Informal Document No. GRSP-38-14-Rev.1

(38th GRSP, 6-9 December 2005,

Japan's Comment on GRSP/2005/5 ECE-R.16

Sled Acceleration (GRSP-37-10)

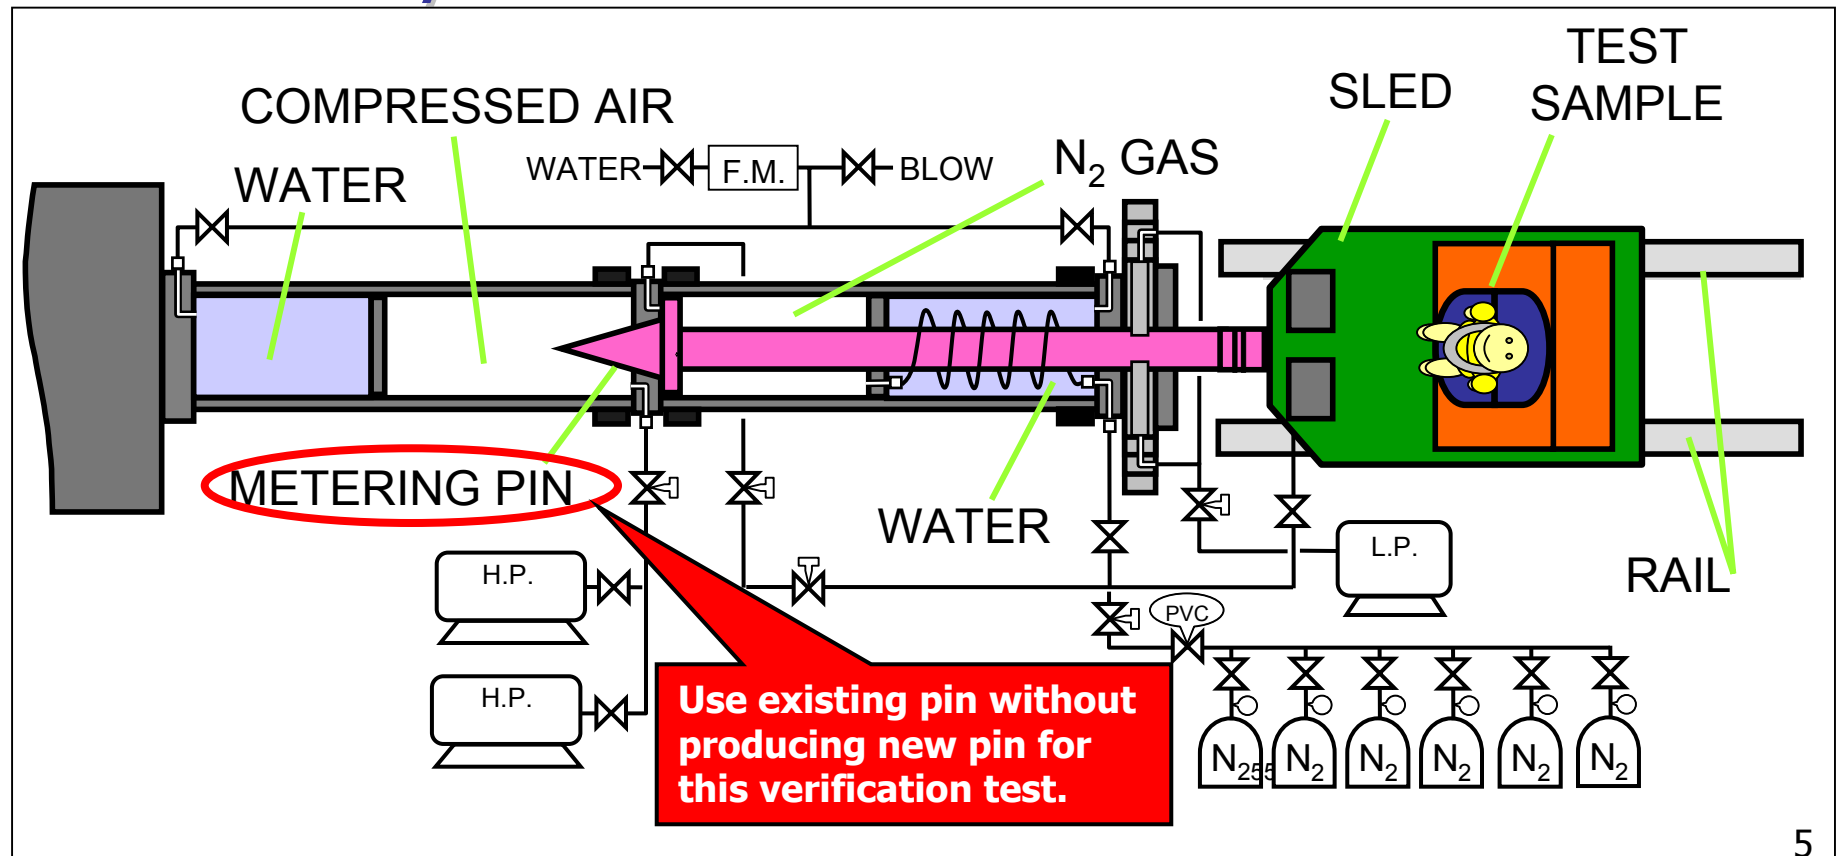
- At the 37th GRSP, we verified if the content proposed in GRSP/2005/5 as below is feasible in HyGe test facilities commonly used in Japan and reported the result:
 - . Acceleration curve within the corridor
 - . Initial slope of acceleration
 - . 5ms-10G & 10ms-20G
 - . Sled total velocity change
 - : $\Delta V = 51 \pm 2/0$ km/h
 - . Sled acceleration distance
 - : $50 \pm 1/0$ km/h = 40 ± 5 cm
- As we reported the result of verification in Informal Doc. GRSP-37-10, we could not produce a sled pulse complying with all requirements simultaneously.
- We decided to conduct a verification test again to see if “Initial slope of acceleration: 5ms-10G, 10ms-20G” can be achieved with the condition excepting “Sled acceleration distance”.

Sled Acceleration (New)

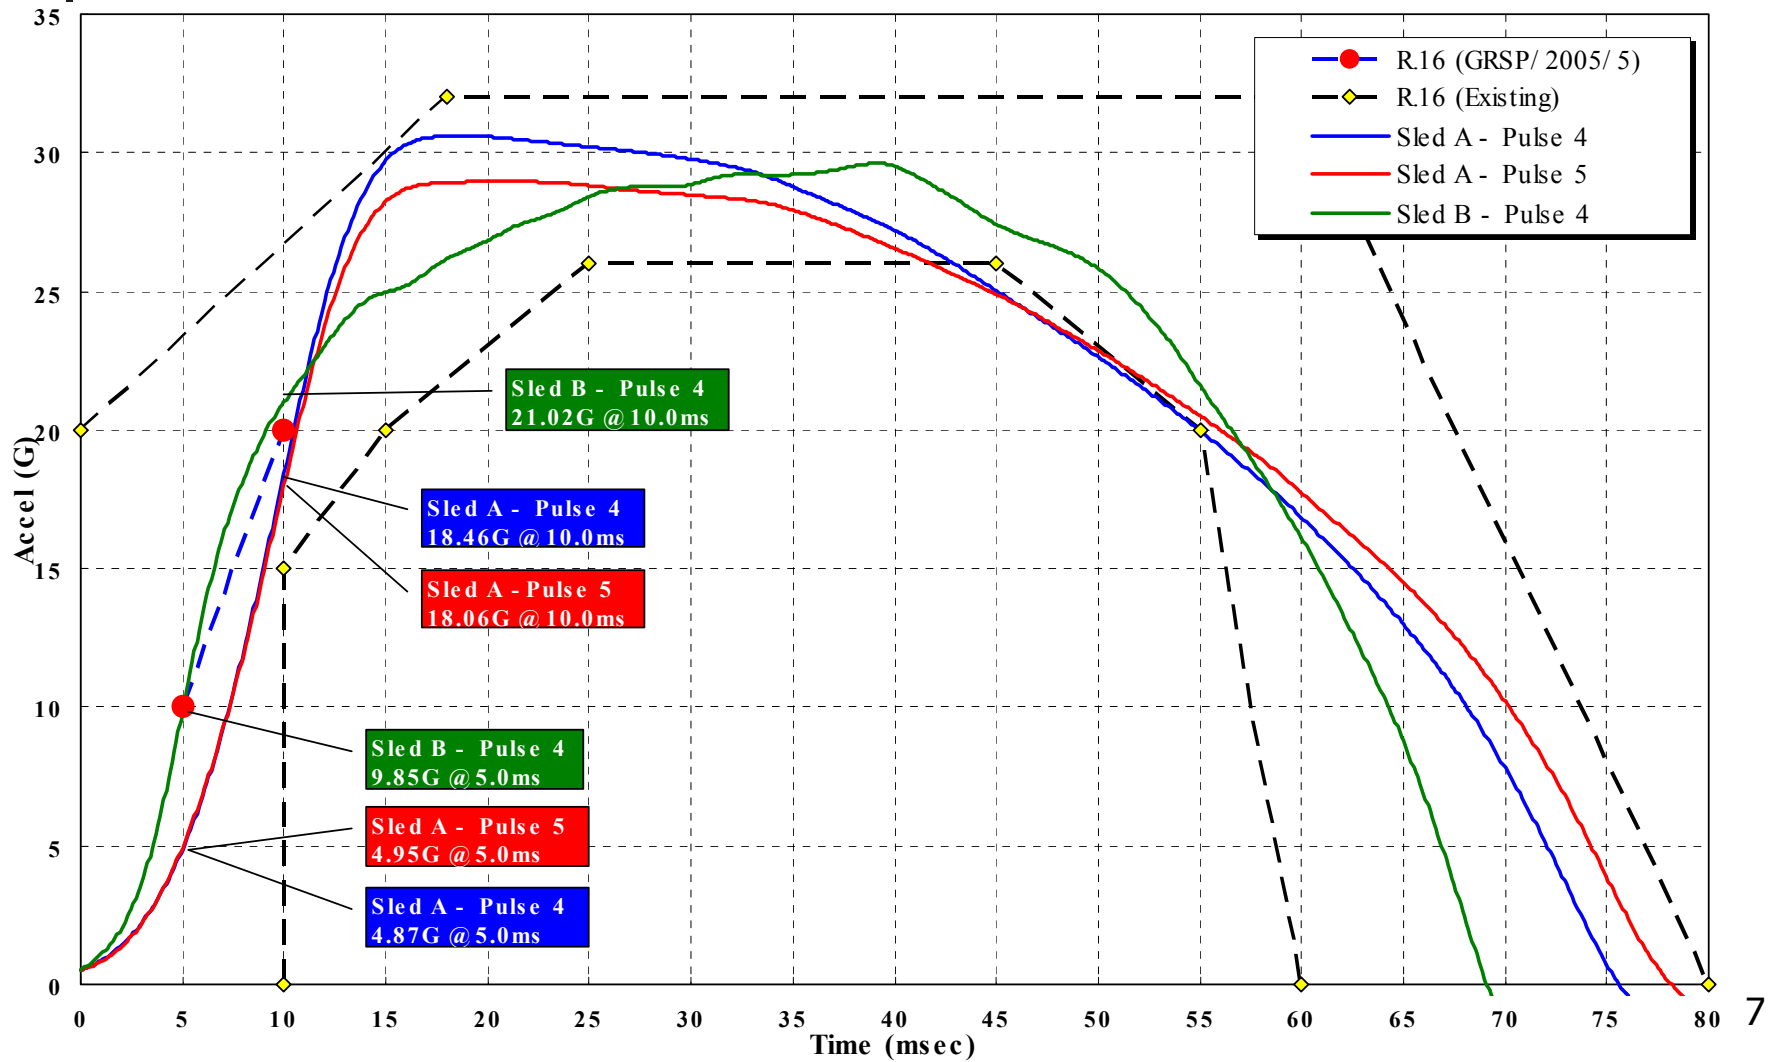
- The test was conducted using existing test facilities in Japan (HyGe). Unfortunately the test results did not fulfill all the proposed requirements.
- Especially as the 12inch HyGe Sled has heavy sled mass, the 5ms-10G and 10ms-20G requirements were very hard to be met for this size sled.

On the other hand, the specified ranges of accelerate corridor and speed will be hard to satisfy when trying to satisfy the initial slope of sled acceleration.

- Proposed conditions were achieved in one test with Sled B of smaller sled mass (9 inch, Sled mass = 700 kg), but could not be achieved in the other tests with Sled A of larger sled mass (12 inch, Sled mass = 1,100 kg).
- We would like to make tuned metering pin for current proposal and conduct verification test with 12 inch HyGe sled again, and then we will review the proposal by the 39th GRSP session.
